Proj. No.: SUR2201

Subject: Addendum No. 2
Surf City WWTF Digester/Sludge Holding Tank
Surf City, NC
Owner: Town of Surf City

ADDENDUM NO. 2

SEAL
Mark F. Weiss
Professional Engineer
No. 31432
8/21/2024

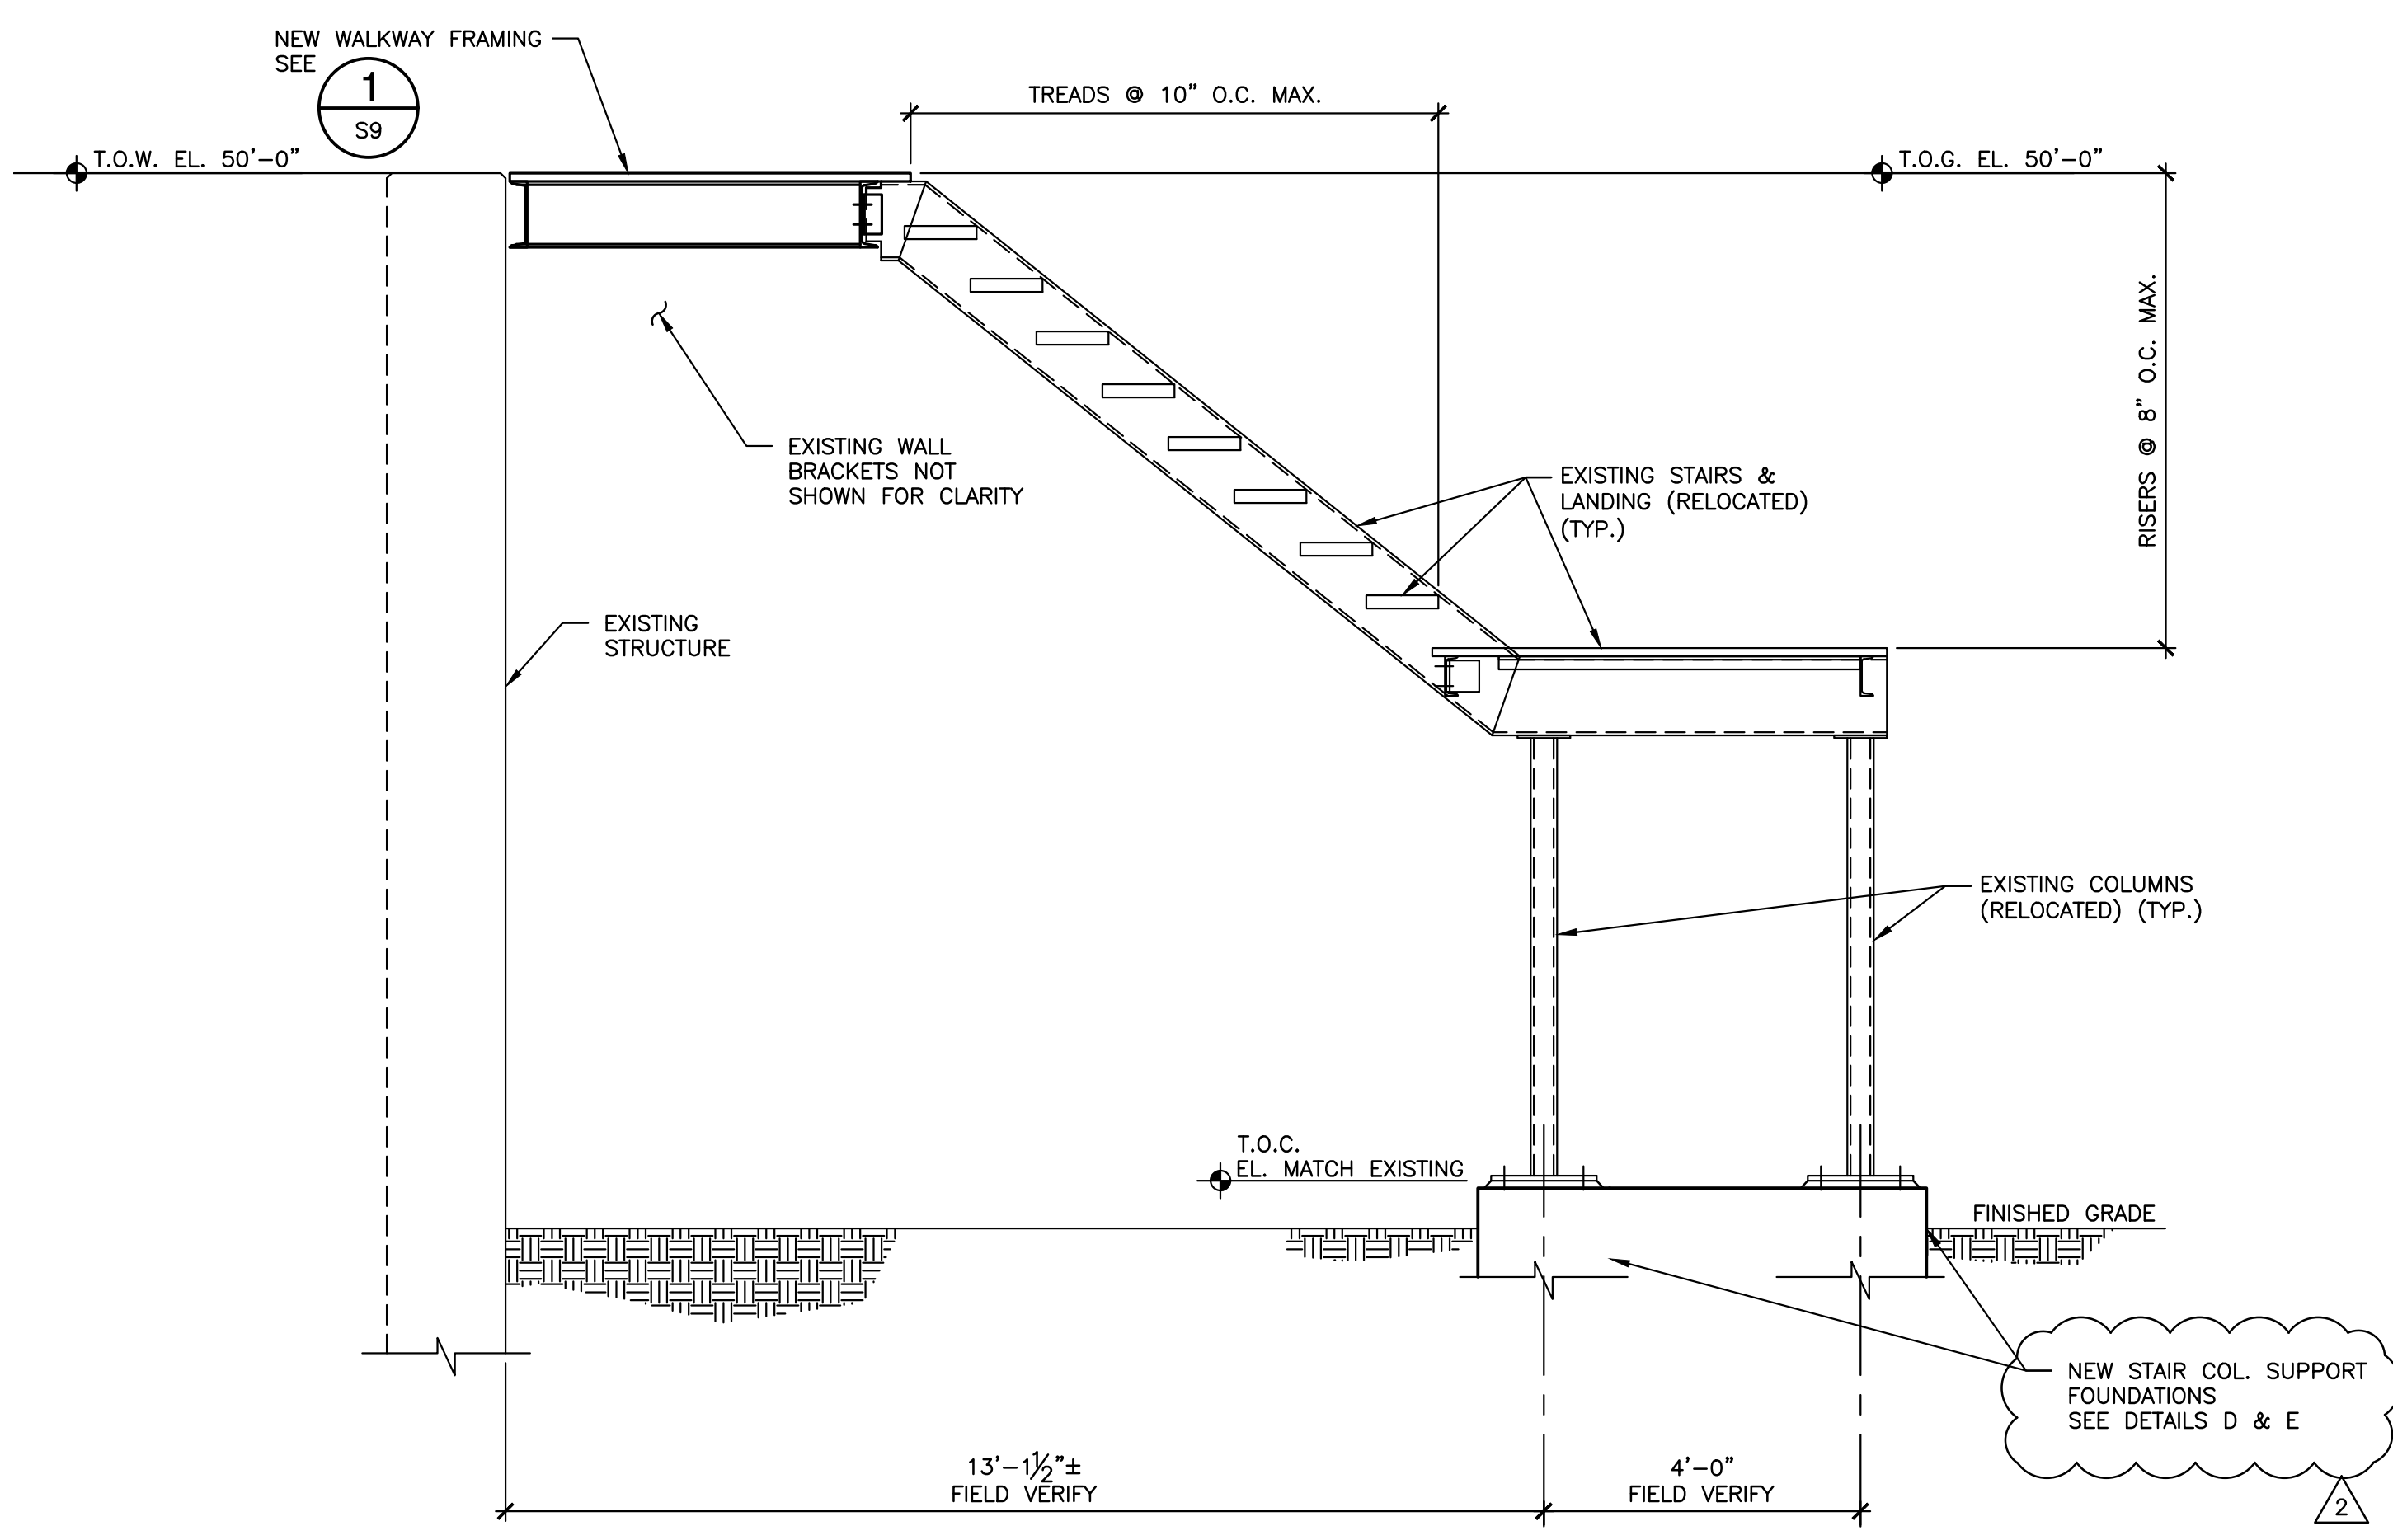
Item 2.27: The proposed walkways and stair modifications shown on Drawing C-1.1 at the existing Aerobic Digester will conflict with an existing concrete pilaster. Please advise.

Extend landing four feet to clear pilaster and adjust stairs, piping and equipment placement accordingly. Revisions will be included in the issued for construction drawings.

D DETAIL AT STAIR FOUNDATION
S13 SCALE: 1/2" = 1'-0"

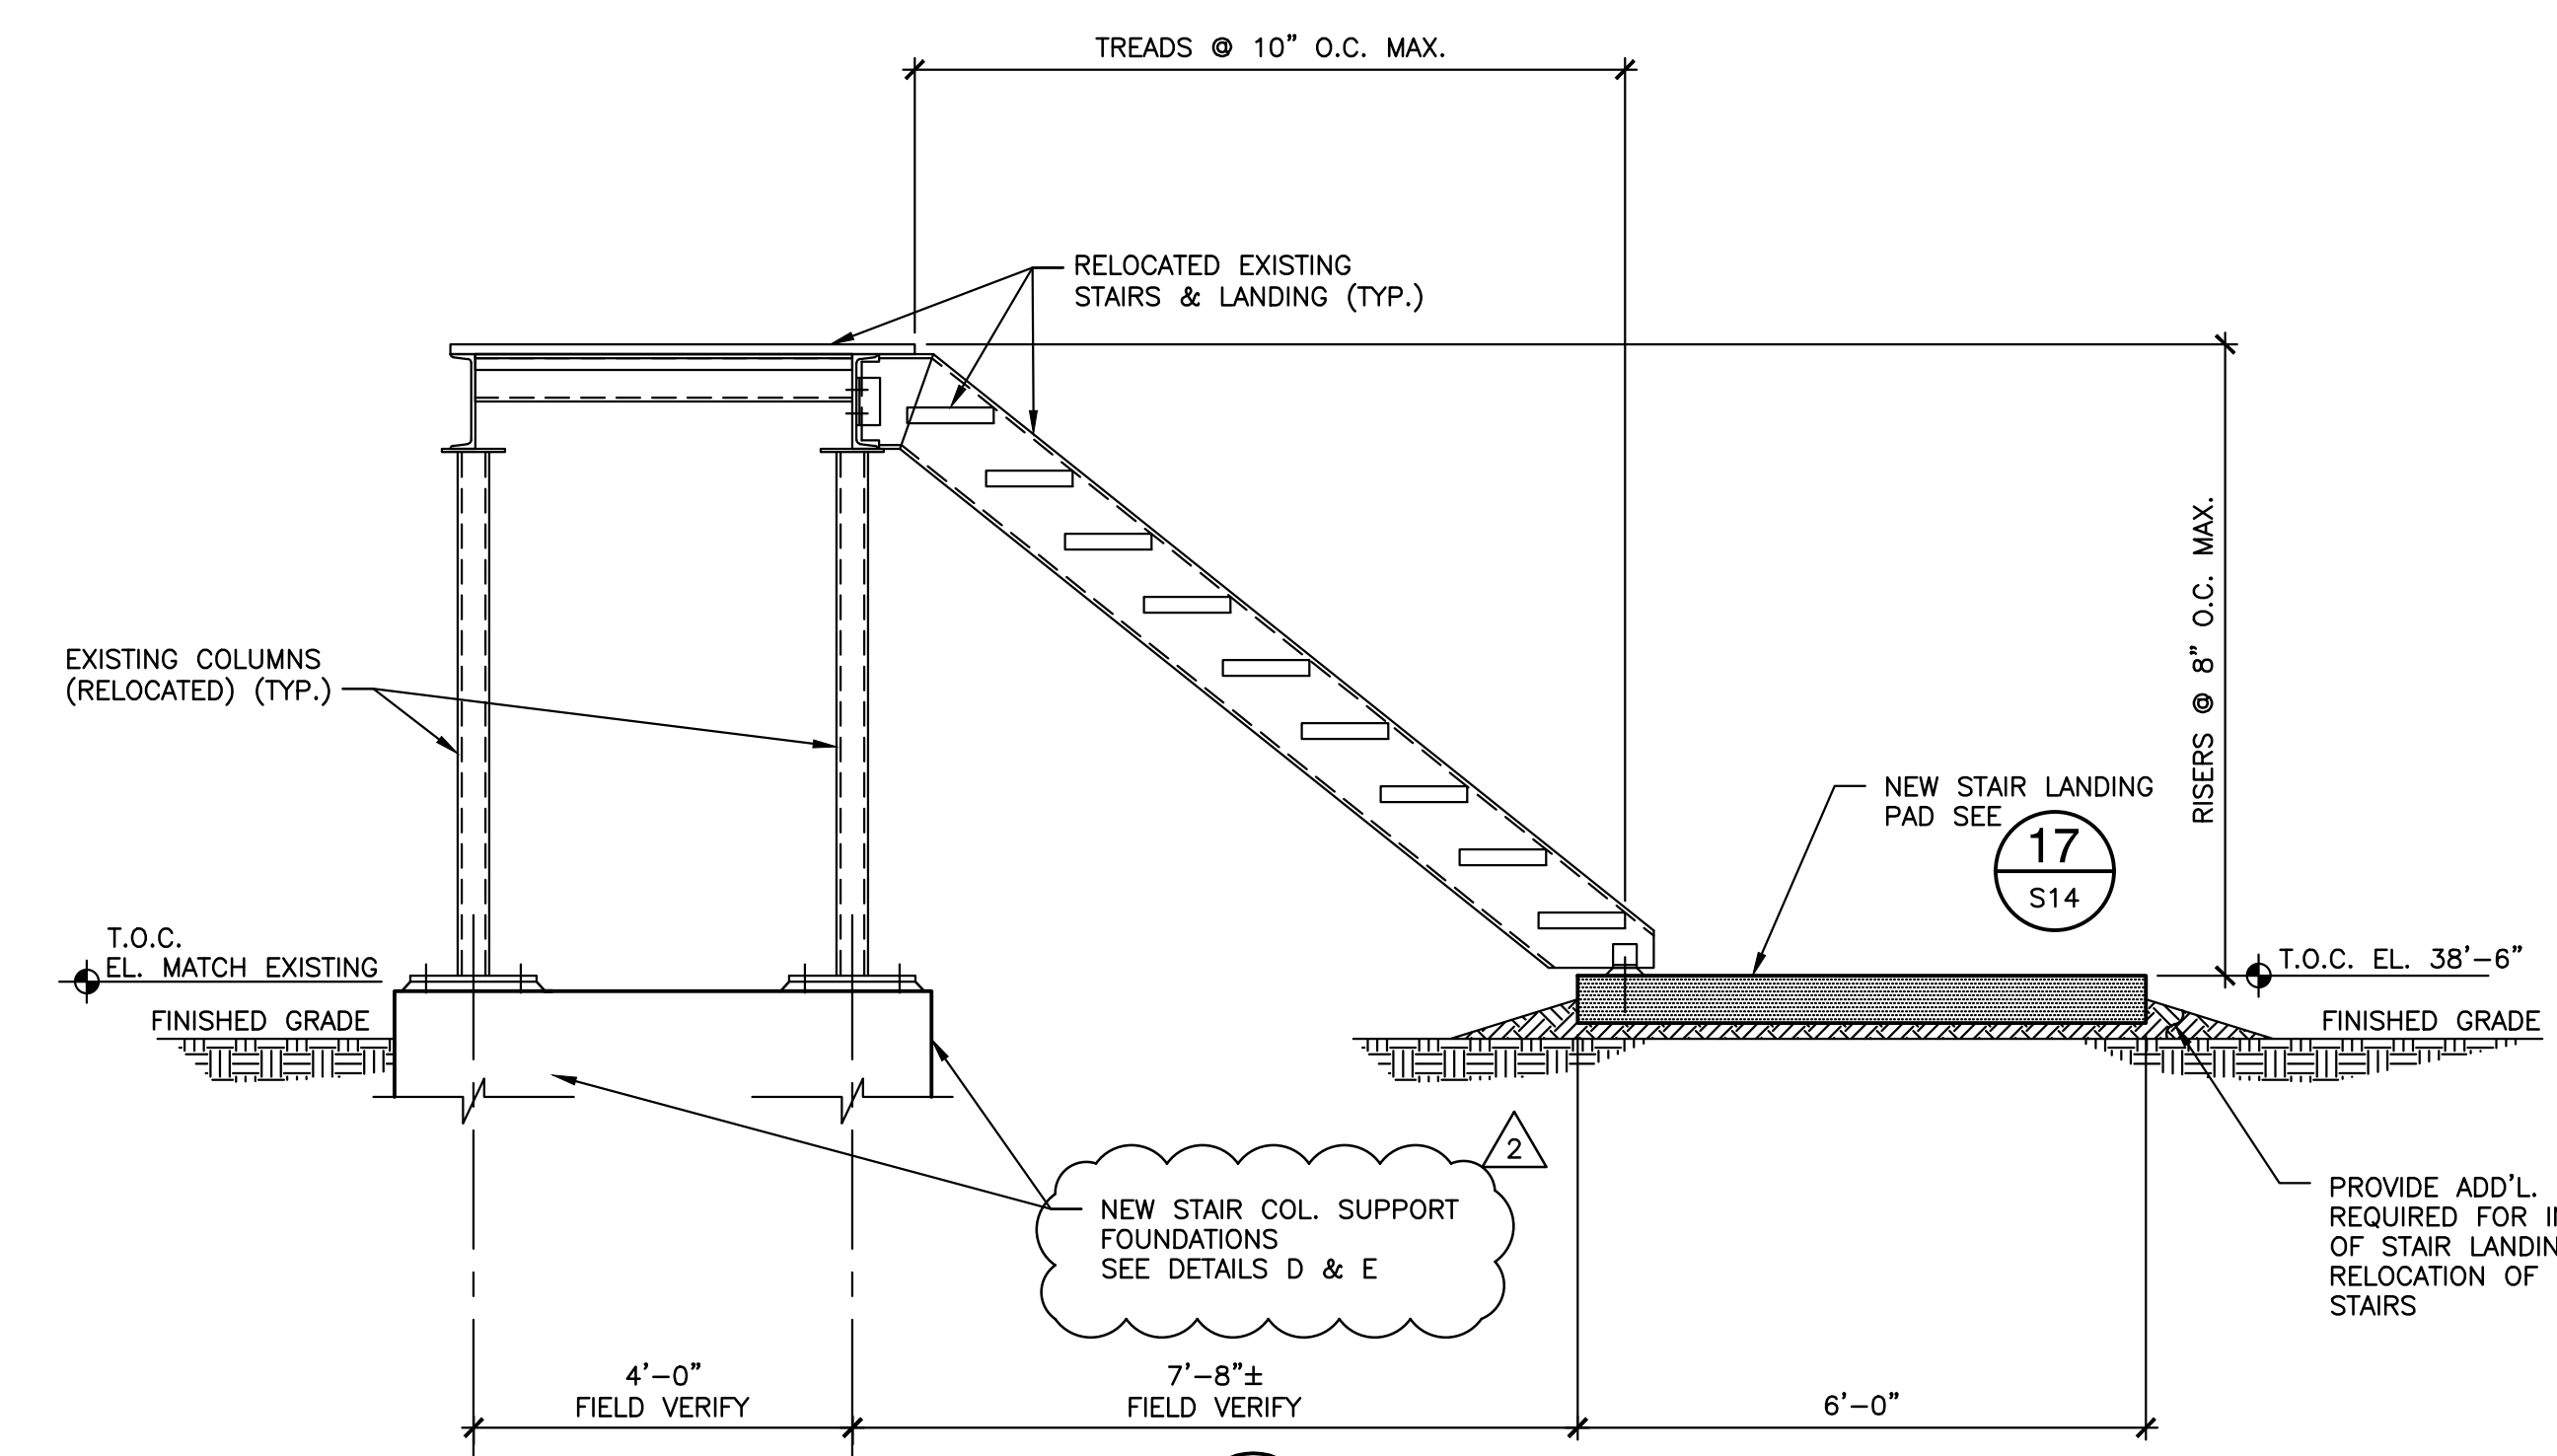
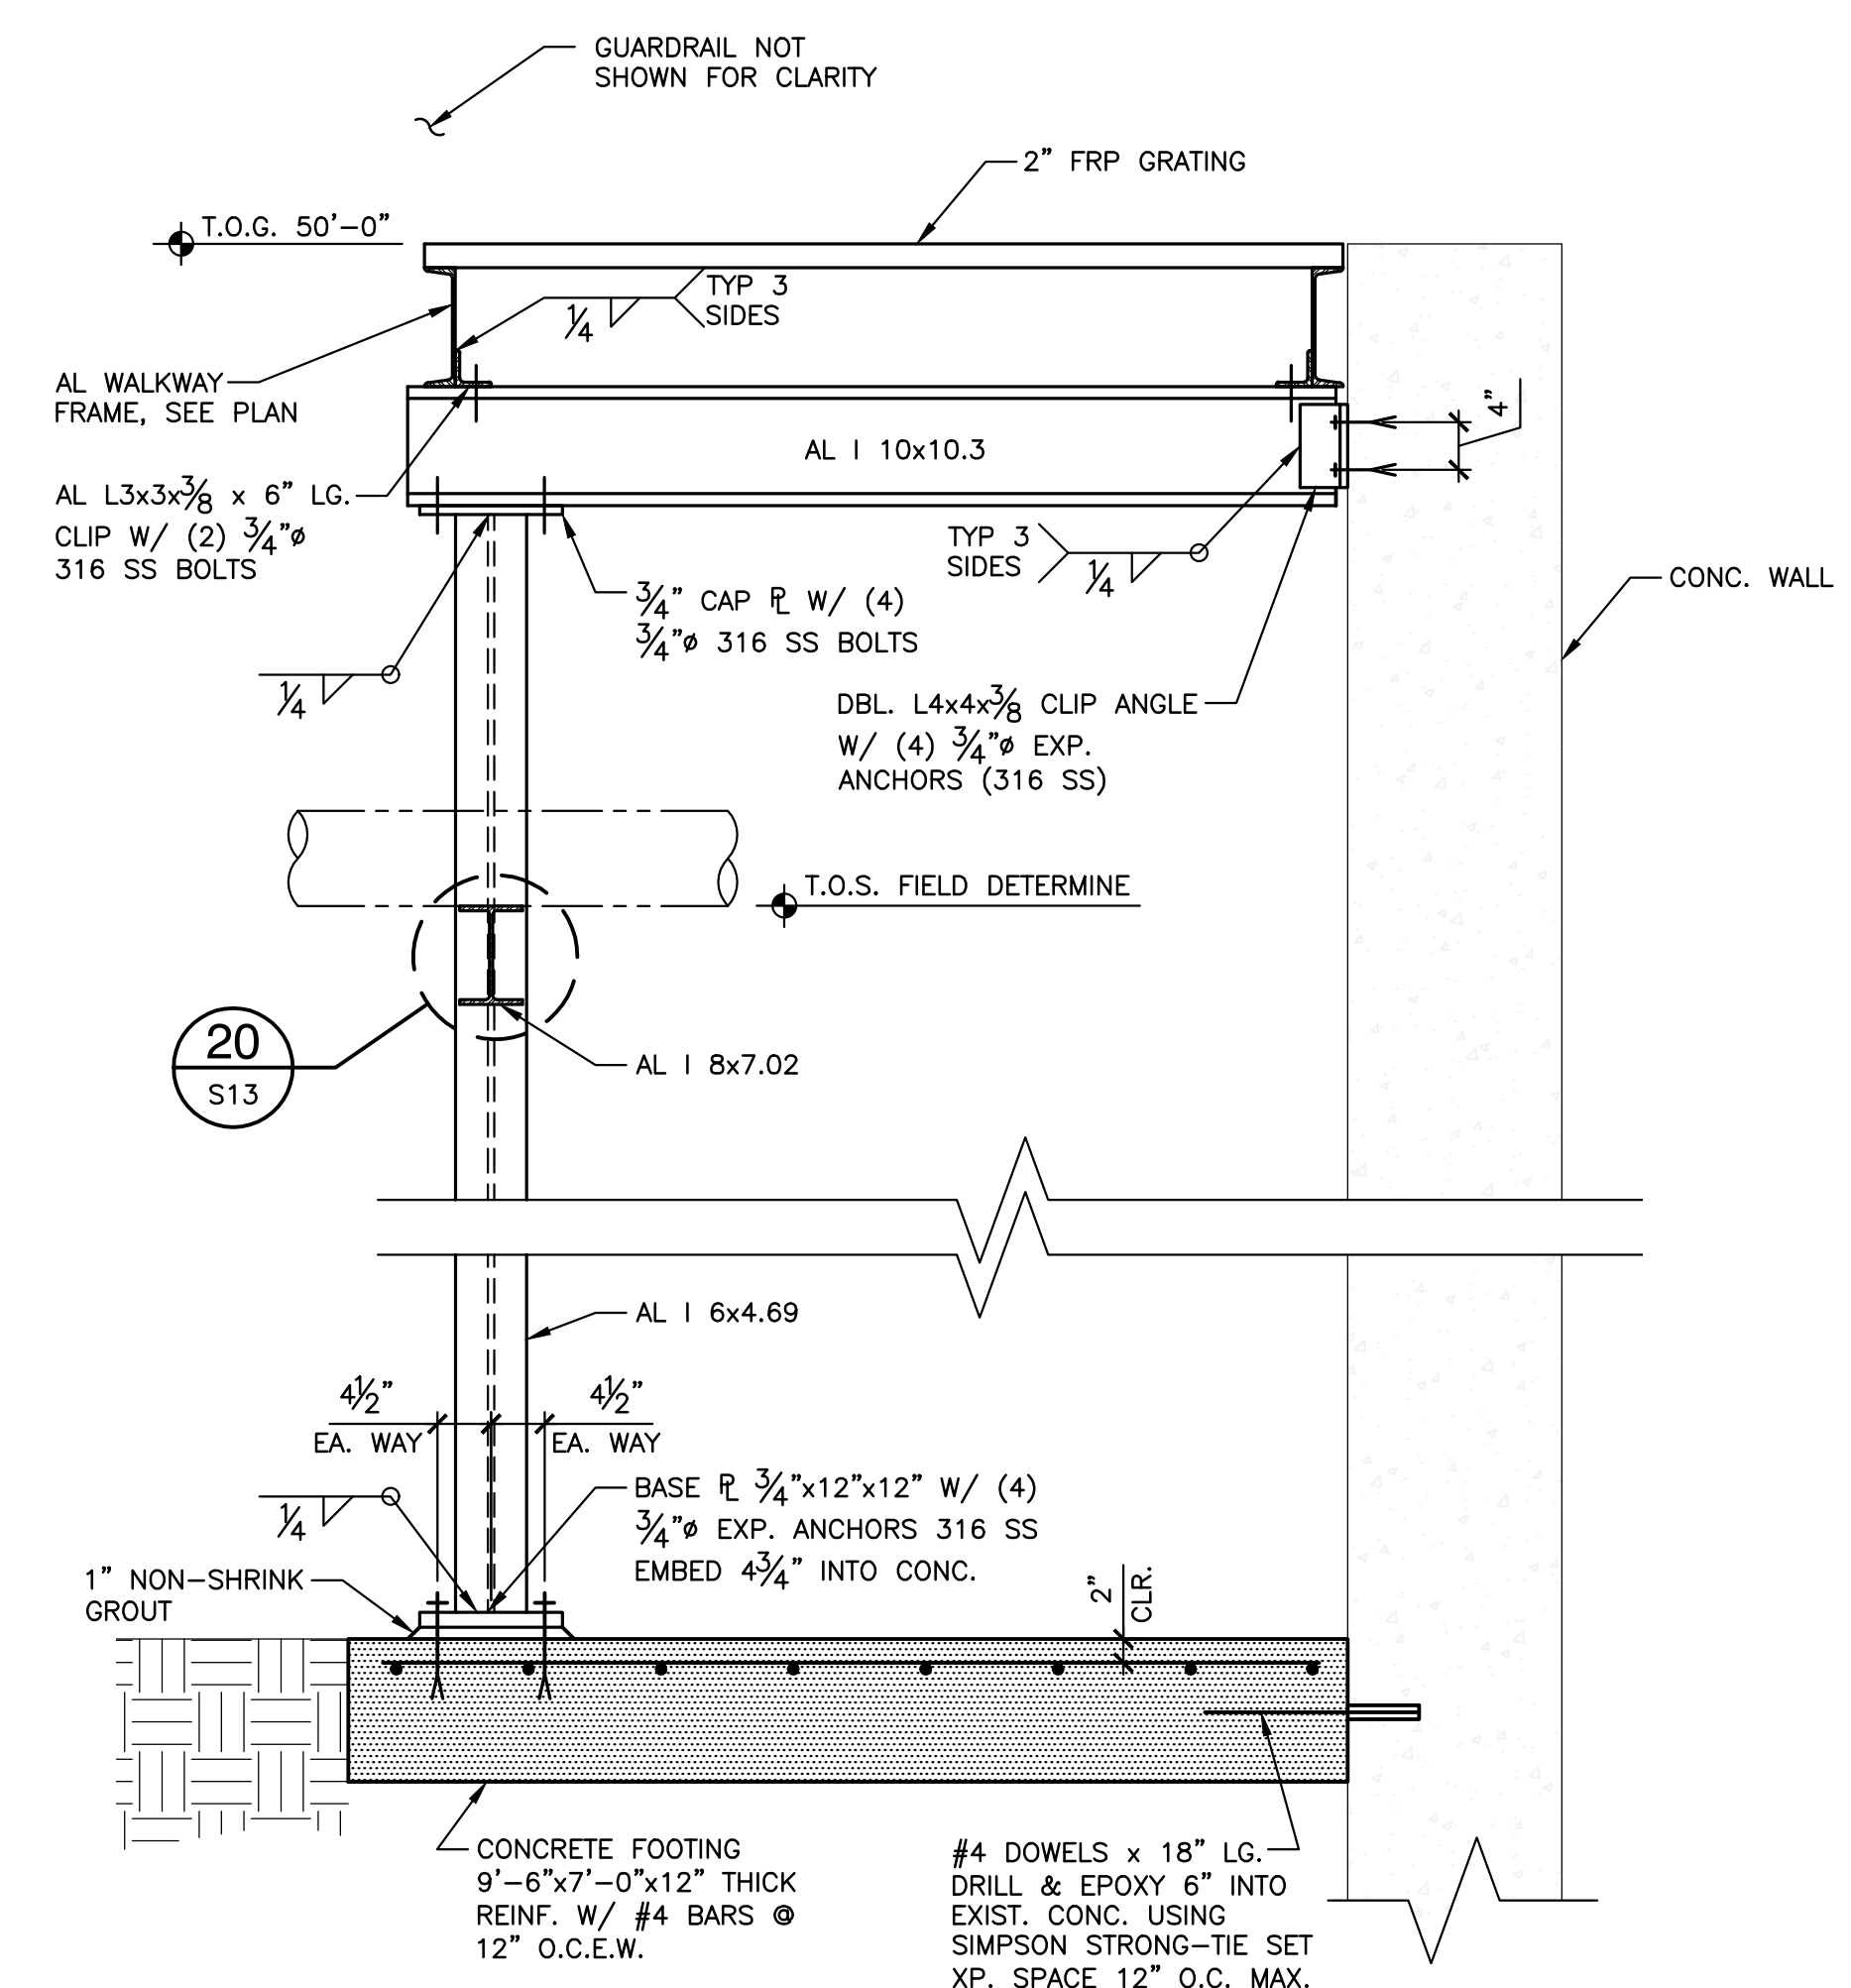
Item 2.22: Please provide a detail for the new stair column support foundations shown on A/S13.

Refer to Sheet S-13 – Stair Sections and replace with the attached.
